**Testimony of
Greg Karras, Senior Scientist
Communities for a Better Environment (CBE)
1904 Broadway, Suite 600
Oakland, CA 94612**

**Before the
U.S. Chemical Safety and Hazard Investigation Board (CSB)**

**Regarding the
INTERIM INVESTIGATION REPORT
CHEVRON RICHMOND REFINERY FIRE
PUBLIC HEARING OF THE CSB BOARD on
19 April 2013 at Memorial Auditorium,
Civic Center Plaza, Richmond, California**

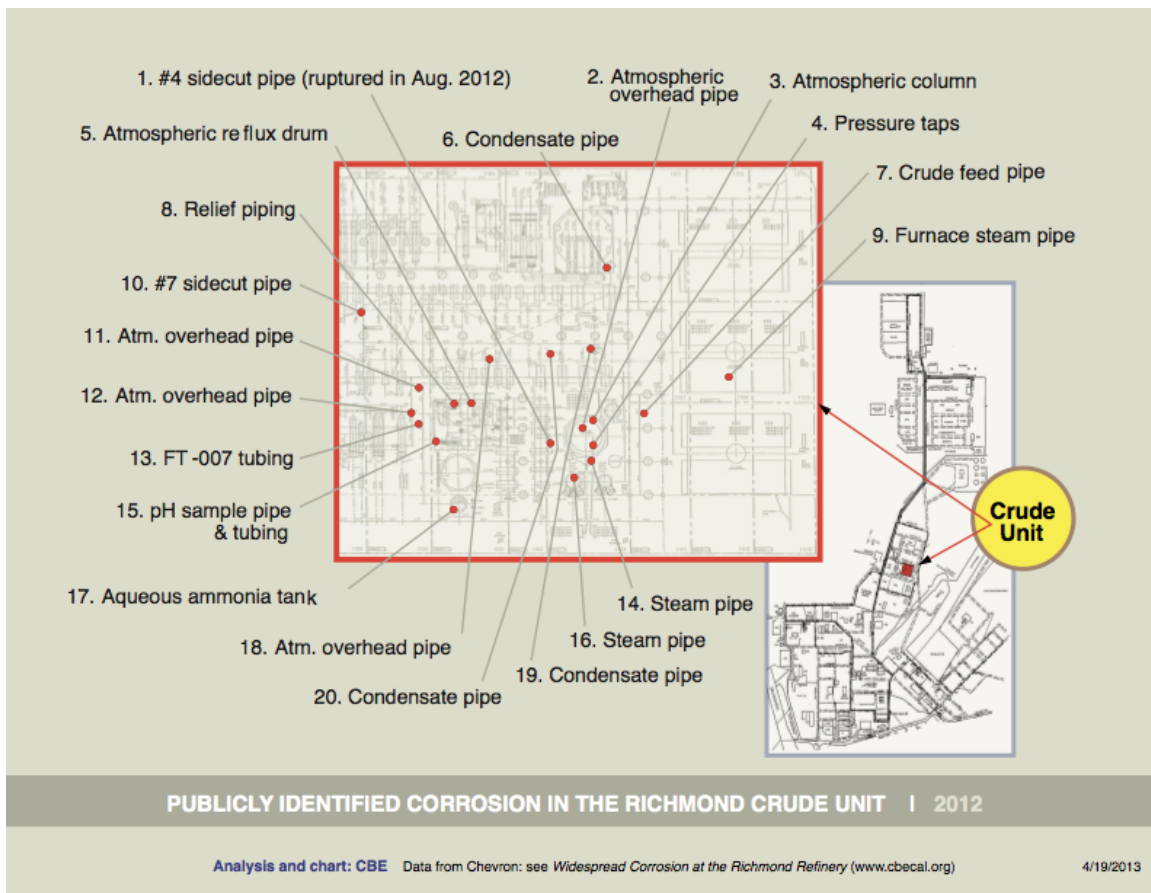
First, the CSB’s interim findings support an urgent need to require *inherently safer systems based on a hierarchy of controls*¹ at the Richmond refinery. Additional evidence, from Chevron’s post-incident repair permits summarized in this chart,² further supports this urgent need at the Richmond refinery and industry wide.

Note points 1, 2, and 12 in this chart. Point 1 indicates the 4–sidecut pipe section that failed in this incident, where your findings demonstrate that the inherently hazardous

combination of more corrosive feedstock and less corrosion-resistant piping metal involved in this incident was at best extremely difficult to manage.

Points 2 and 12 in this chart indicate sections of atmospheric overhead piping where Chevron reported finding internal corrosion pitting severe enough to indicate a failure risk before the next scheduled maintenance shutdown (5-year intervals for this unit at this time) was found only after fire-damaged pipe was cut out and removed, and extensive internal checking was done.³ Chevron suggests the need to monitor thousands of pieces of equipment and thousands of miles of piping at Richmond.⁴ Thus, new information suggests that, at least in some cases, inherently hazardous refinery technology might, as a practical matter, be impossible to manage.

The CSB’s proposed findings indicate that no U.S., state, or local officials require inherently safer technology in high-hazard industries. This indicates a fundamental failure of safety policy here and nationwide that warrants adopting your proposals that would require inherently safer systems based on a hierarchy of controls as urgent recommendations tonight.

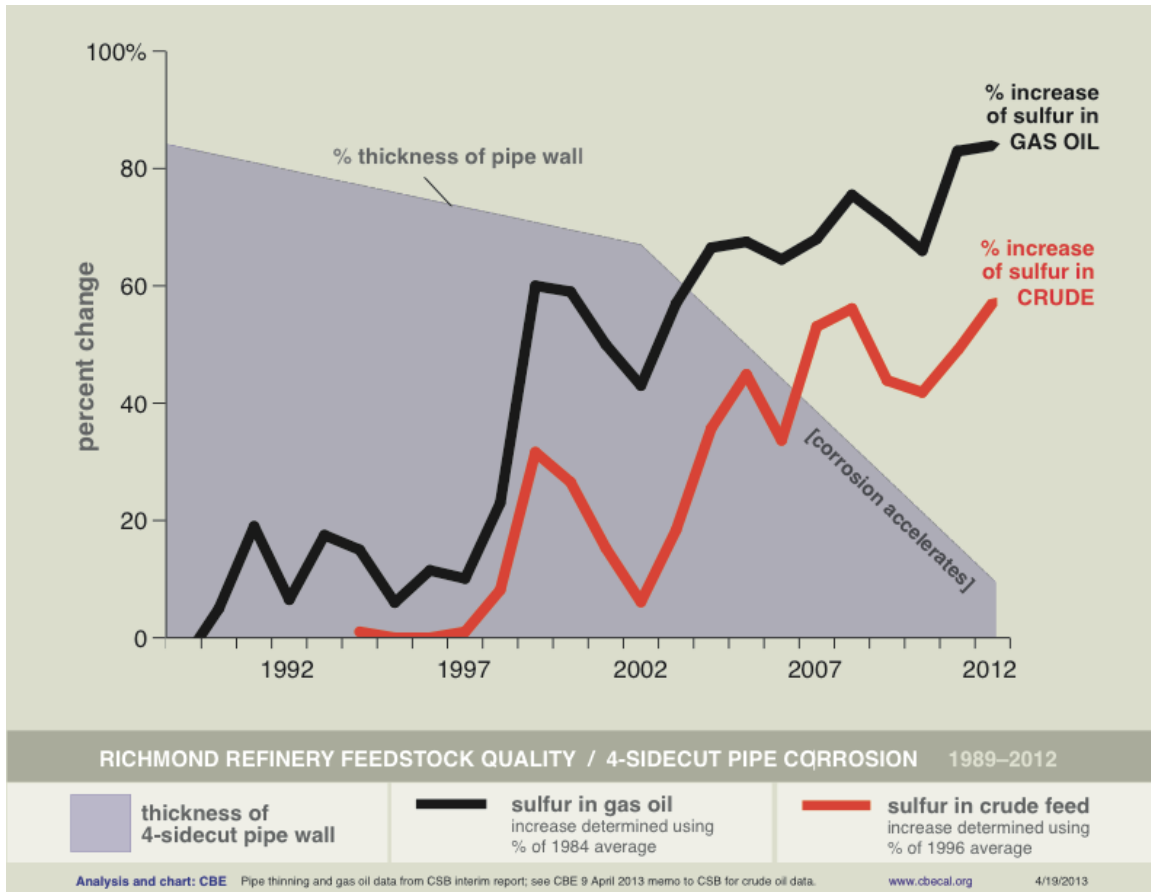
Second, in its ongoing investigation and final report regarding this incident, the CSB should complete its analysis of material input substitution. Data on corrosion in the pipe section that ruptured in the incident, sulfur in the gas oil running through this pipe, and sulfur in the refinery crude feed supplying that gas oil, are shown in this chart.⁵ The percent change from baselines is shown.⁶

As sulfur increased in the crude, it increased in the gas oil distilled from that crude and running through the 4-sidecut pipe section, and sulfidic corrosion began to thin the wall of this pipe more than four times faster than before that dramatic sulfur increase. Thus Chevron's feedstock switch played a key role in this incident.

⁷ Background on three details of the oil quality and pipe corrosion evidence shown in the second chart may help to explain and support this additional evidence. The chart shows that the pipe wall thinned 4.4 times faster after the sulfur content of the crude and atm. gas oil feeds increased dramatically. This is a conservative estimate based on publicly available data that show a pipe wall loss of ~33% by 2002 and of an additional ~57% by 2012. It is possible that more than 57% of the original pipe wall thickness was lost after the dramatic gas oil sulfur increase (1998–1999) because of accelerated sulfidation corrosion that began to occur before the first pipe thickness measurement was reported (in 2002). This possibility may be hard to confirm or reject: based on discussions with CSB and USW staff I understand that Chevron may not have obtained, kept, or reported pre-2002 thickness measurements for this pipe section.

The chart also shows that the percent increase in gas oil exceeds that in crude. I expected to see this for two reasons. One is that this refinery shifted to a crude feed dominated by Persian Gulf crudes with atmospheric gas oil cuts that are proportionately higher in sulfur (as a percentage of sulfur in whole crude) than the Alaska North Slope crude stream that dominated its crude feed earlier in the 1990s. The other reason is that an increase in atmospheric gas oil temperature in the Richmond crude unit (noted in the CSB interim report) indicates that a cut-point change sent denser gas oil, which generally has higher sulfur content, through this 4-sidecut pipe circuit.

In my opinion, in its ongoing investigation and final report regarding this incident, the Chemical Safety Board should consider completing its analysis of inherently safer chemical inputs for refineries.
